CITY PLANNING COMMISSION AGENDA

B.1 - CPC PUZ 14-000124 - QUASI-JUDICIAL

B.2 - CPC PUD 06-00108-A7MJ14 - QUASI-JUDICIAL

PROJECT: DUBLIN NORTH PHASE 8

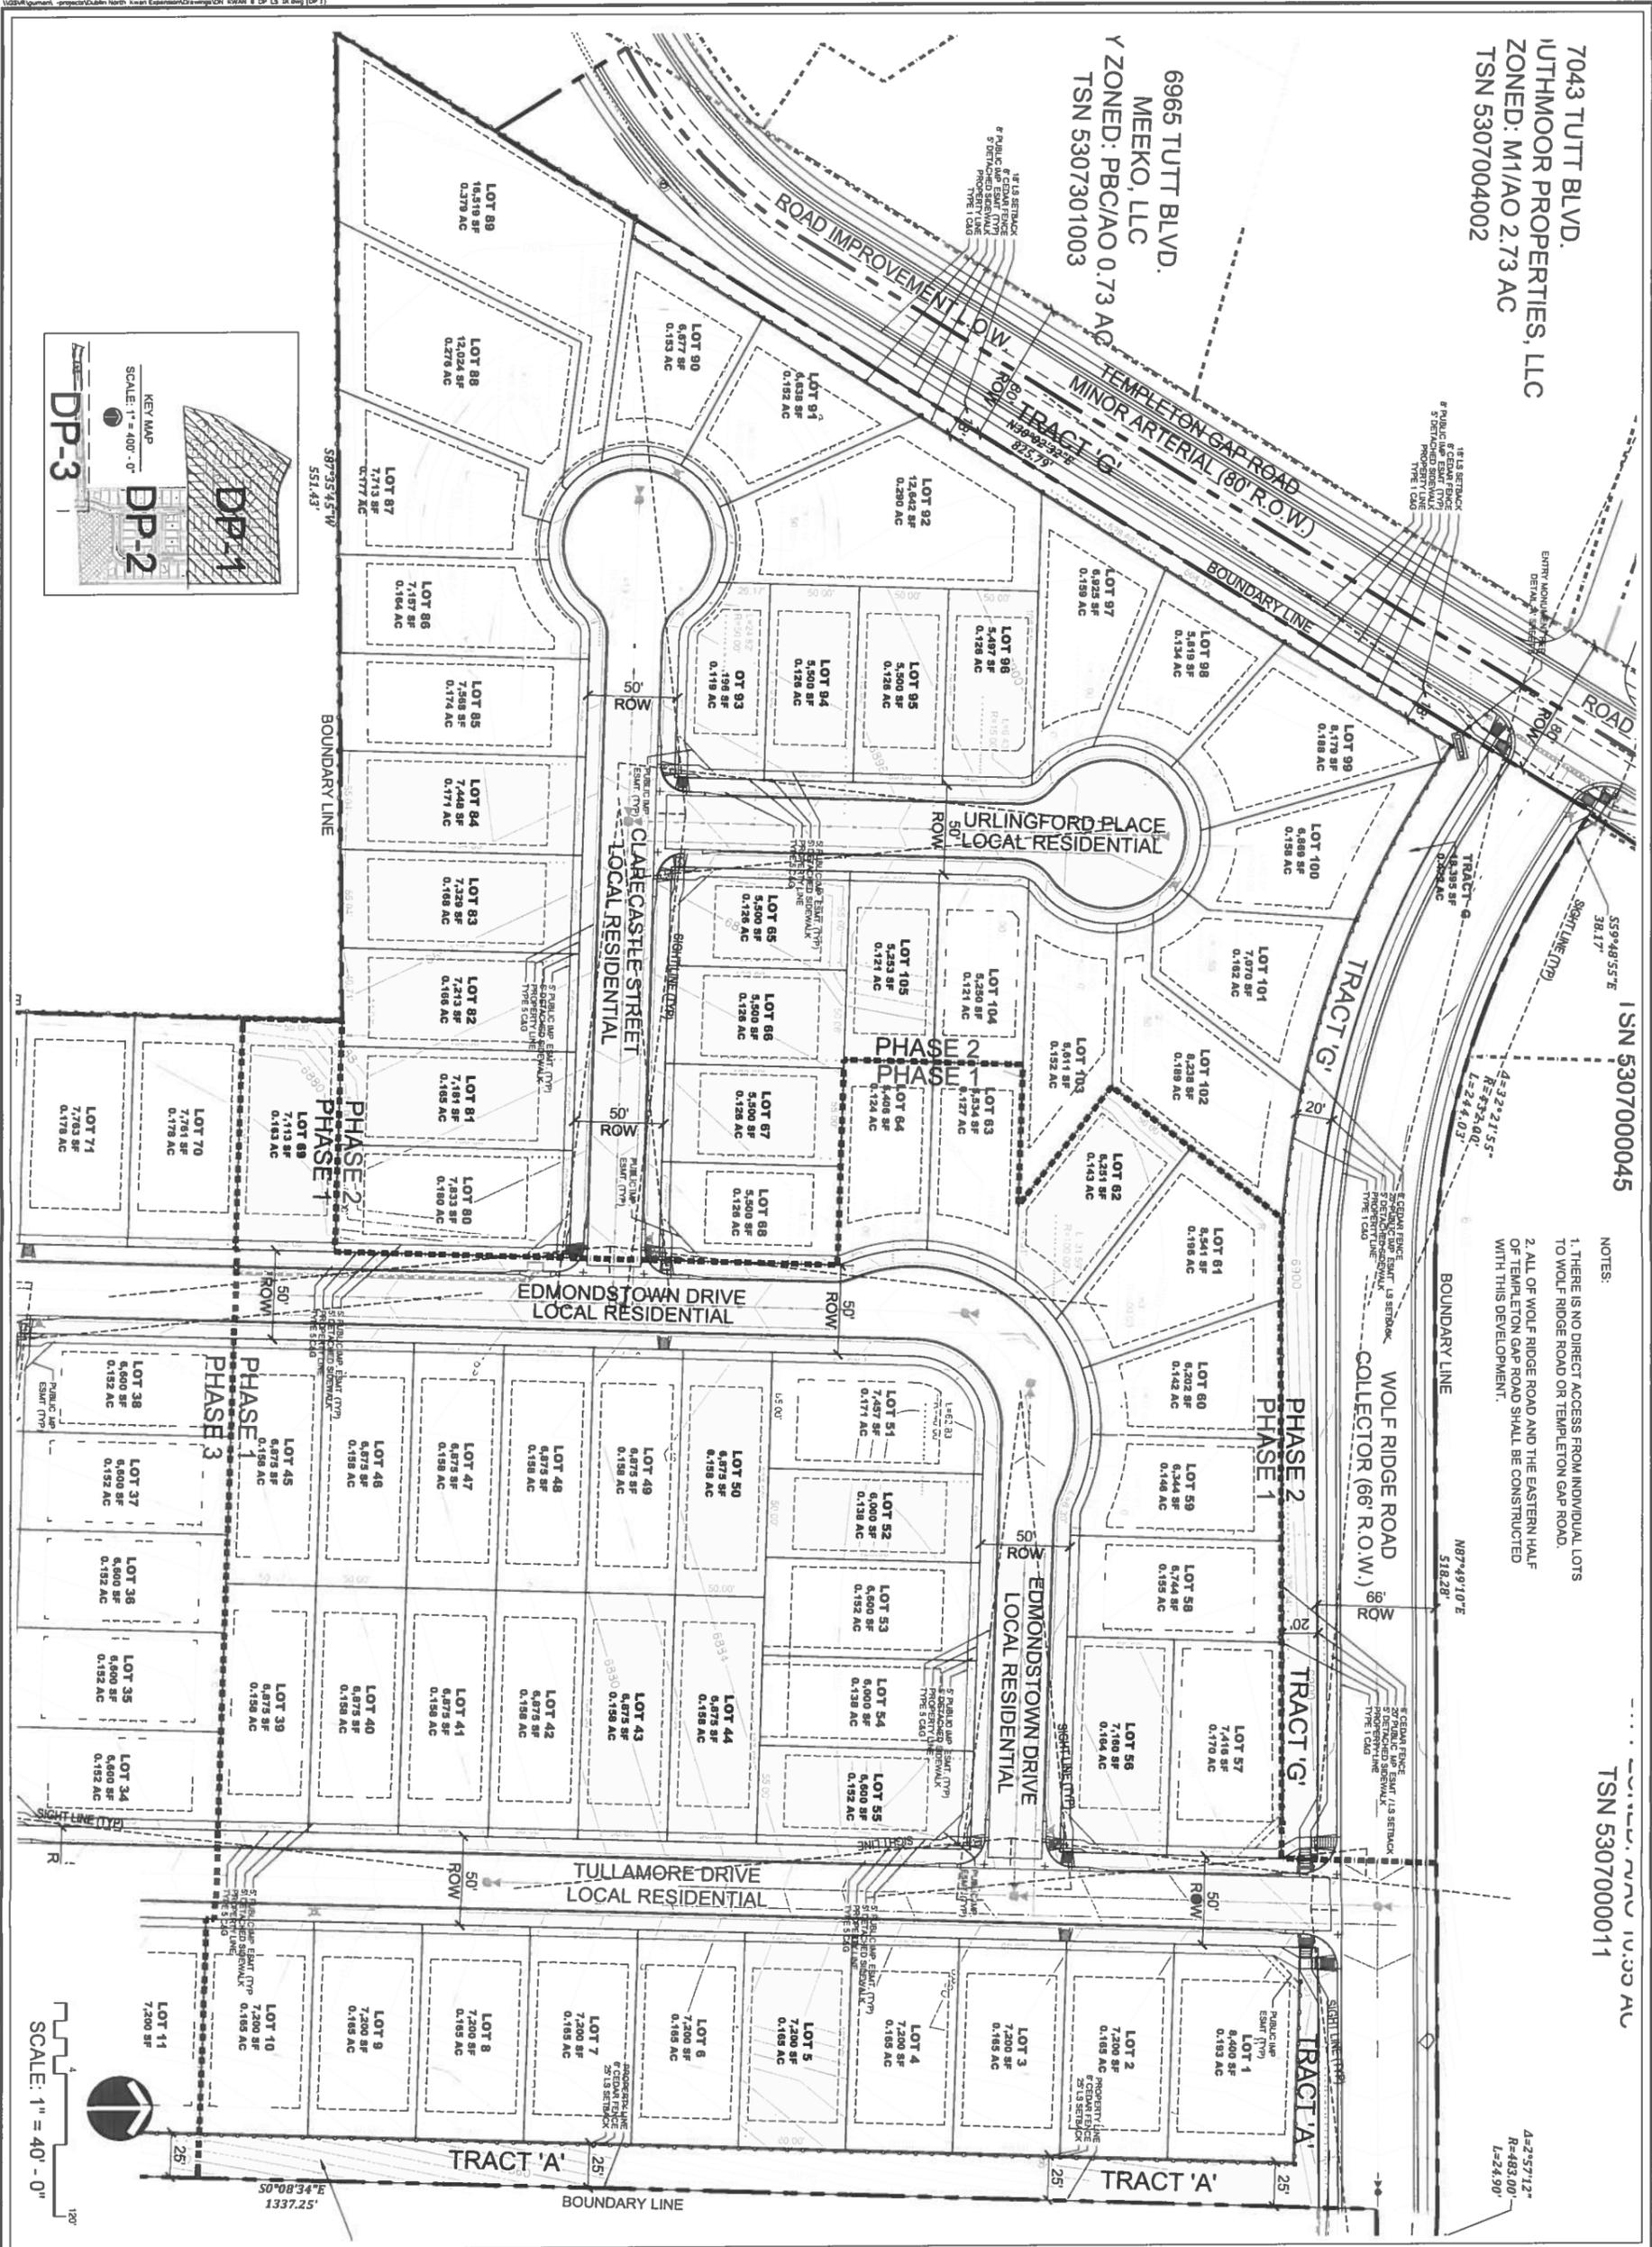
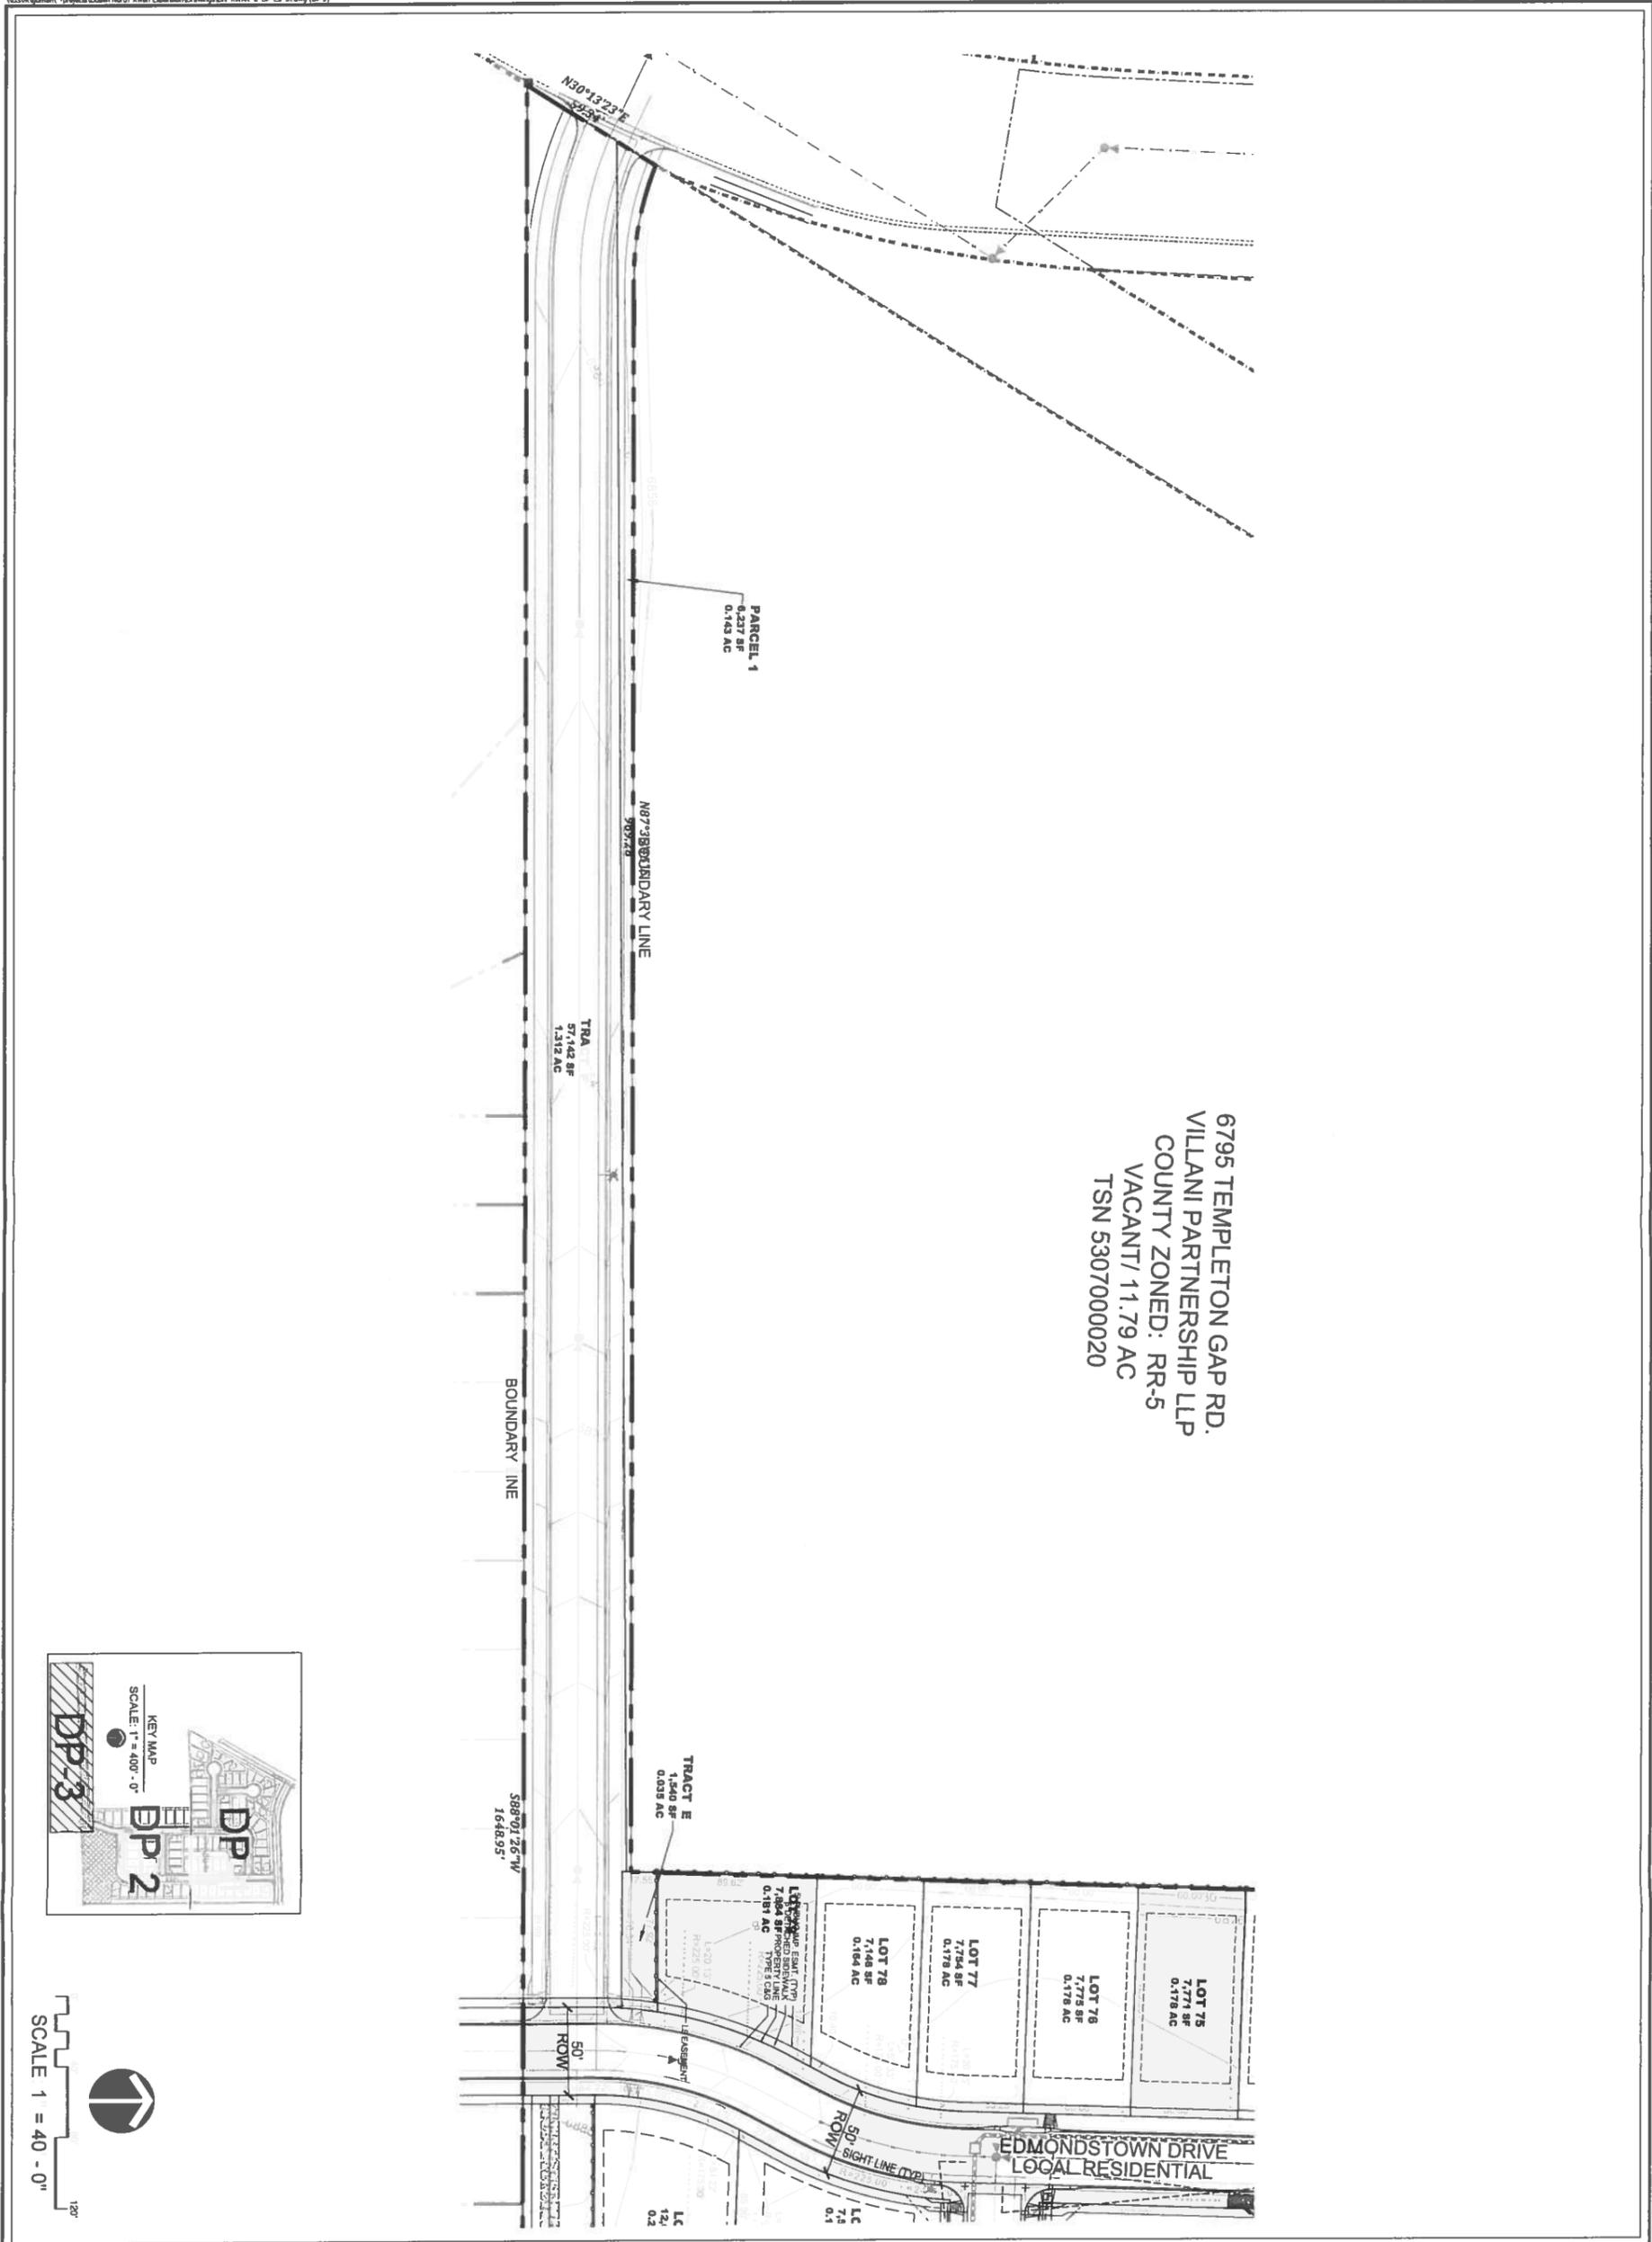
1. Revise the Tract Table on Sheet 1 to state that the maintenance of drainage facilities within all tracts will be done by the Dublin North Metropolitan District No. 3. The only exception is that Tract B will have public storm sewer that will be maintained by the City, however the surface maintenance of the detention pond will be done by the Dublin North Metropolitan District No. 3.

- 4- A westbound right turn lane, with 200 feet and appropriate taper length.
 3. Add a note to Page 1 that Stone Mesa Point is accepted by the City as a public street.

4. Please revise Note 2 on Sheet 1 to indicate that the full mat width of asphalt will be constructed with Phase 1 and only the curb and gutter and sidewalk on the west side of T-Gap will be constructed by the adjacent property owners when they develop.

5. Please remove Note 3 as this is covered in Note 2.
 6. Please add the following note to Sheet 1, "If traffic volumes warrant a signal at the intersection of Templeton Gap Road and Wolf Ridge Road, traffic movements will be restricted."
